Consists of response to questions forwarded in NRC's ltr of 11/23/77 concerning the Steam Generator Tube Leakage Safety Assessment Rept...

PLANT NAME: OCONEE UNITS 1 - 3  
jcm 01/04/78

RE: Oconee Nuclear Station  
Docket Nos. 50-269, -270, -287

The attached information is in response to questions forwarded in your letter of November 23, 1977 concerning the Steam Generator Tube Leakage Safety Assessment Report which was forwarded by my letter of September 9, 1977.

FIGURE 1: RCS AVERAGE COOLANT TEMPERATURE VS TIME

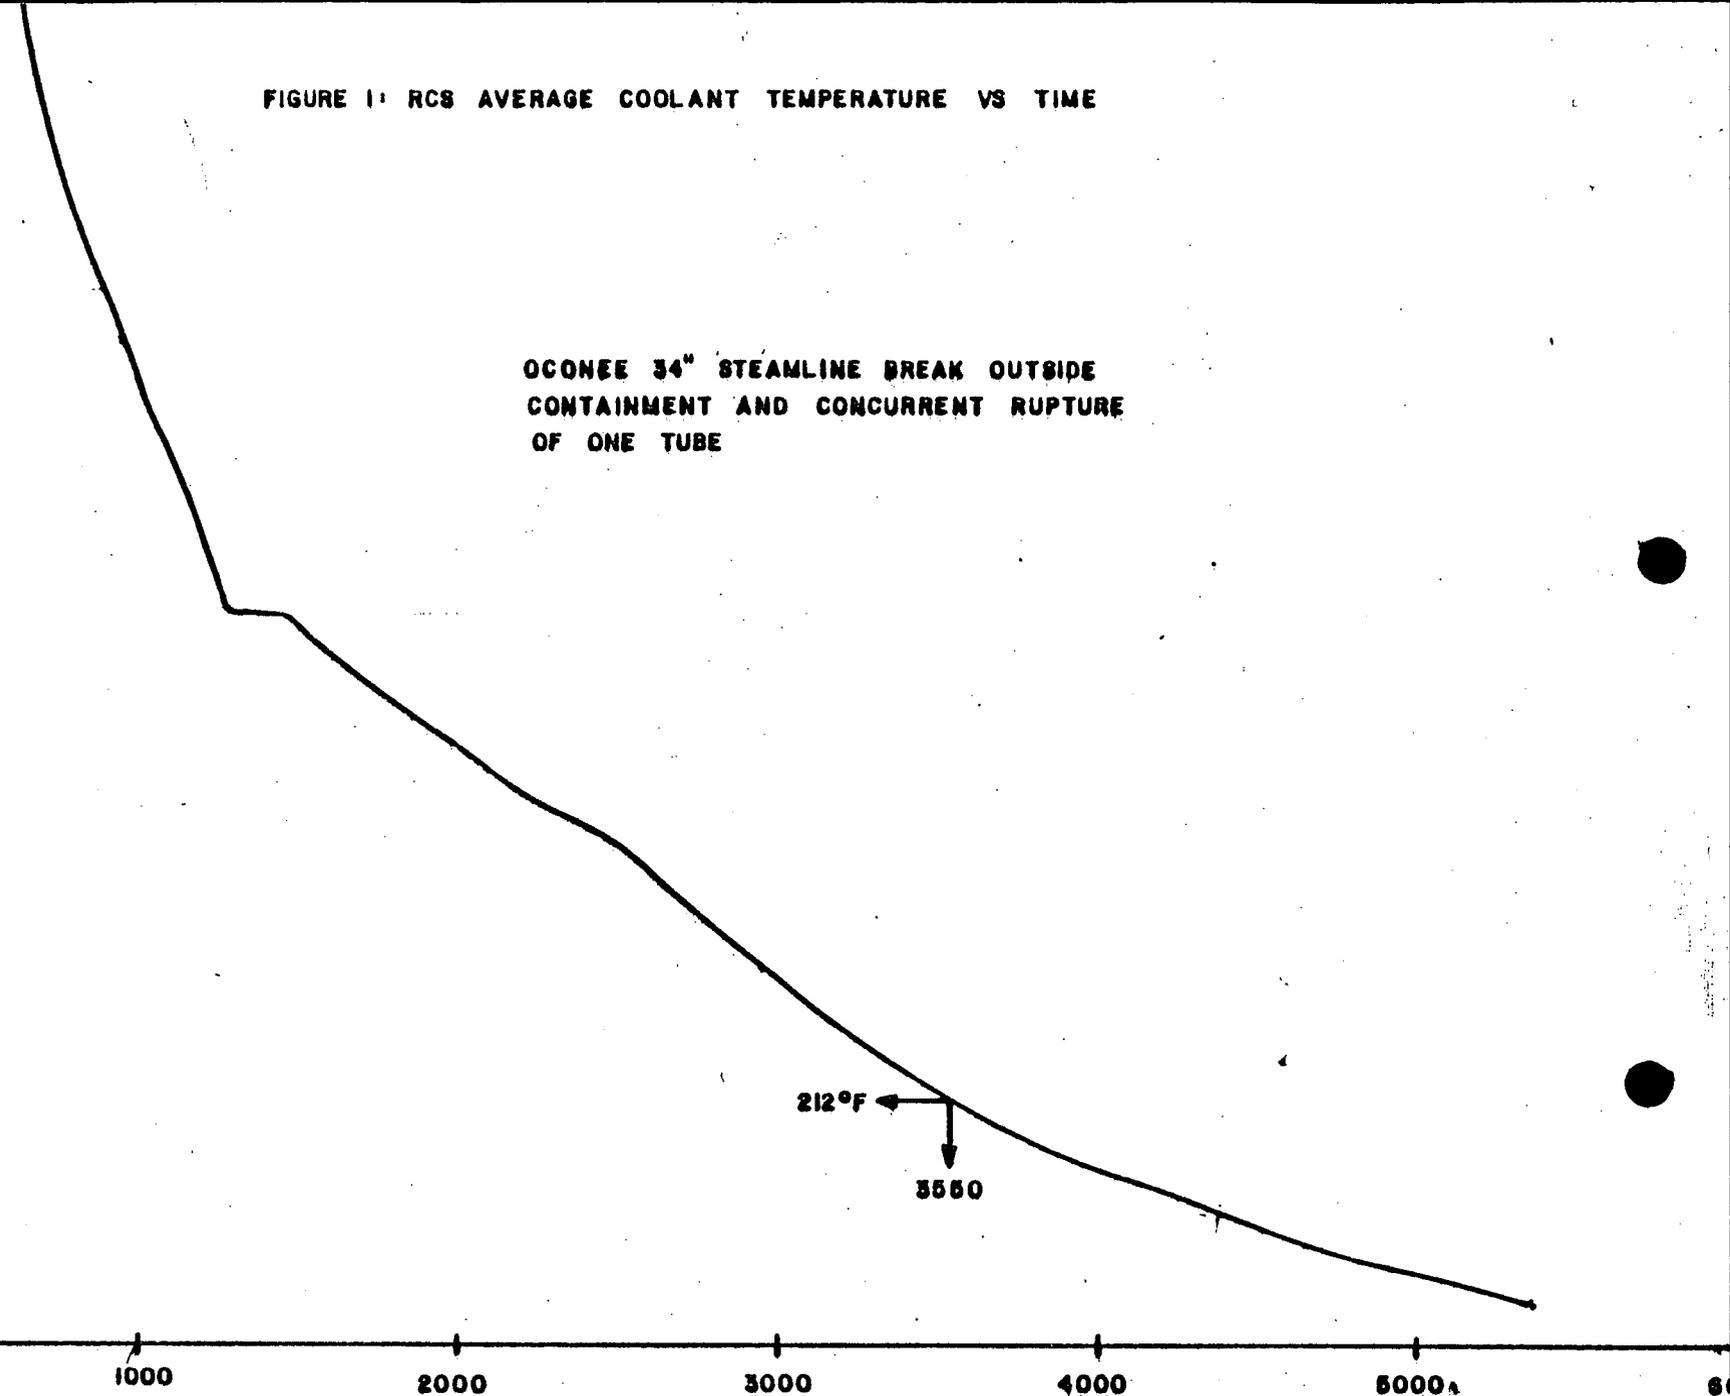
Your report states that operator action to switch off the safety injection would be conservative because it results in minimum dilution. Justify that this action is conservative. Explain the effect of delaying this action. The concern is that continuation of the safety injection will keep the system pressure at a higher level and would result in higher releases, in spite of the increased dilution.

This appears to be particularly important for the cases of one and three tube failures for which the leak rate is calculated to be increasing at a high rate at the time that the safety injection is switched off.

Analyze this accident assuming different times for operator action (e.g., 10 min., 20 min., etc.)

An effect of delaying the time of operator action until the pressurizer liquid level reaches the nominal level ( $\sim 20$  minutes) has been studied. The original computer analysis of one tube failure was continued beyond the 600 seconds into the accident without assuming operator action to switch off safety injection or auxiliary feedwater. At 725 seconds, the empty, but steam filled, pressurizer, which is controlling the pressure of the RCS, started filling up with colder RCS water. This resulted in a large sudden depressurization in the pressurizer due to the thermodynamic equilibrium model assumption in the CFAFT 2 code. Hence, the case was analyzed beyond 725 seconds using hand calculations.

The calculated leak rates, RCS coolant temperature, and RCS pressure beyond 600 seconds are shown in the Figures 1 through 3 respectively. The average coolant temperature of  $212^{\circ}\text{F}$  is reached by 3450 seconds. The primary pressure reaches 25 psia by 5368 seconds corresponding to a total leak rate of 4.82 lbm/sec which was assumed constant thereafter. Once the RCS temperature falls near  $212^{\circ}\text{F}$ , the secondary side of the steam generator would start filling with water.
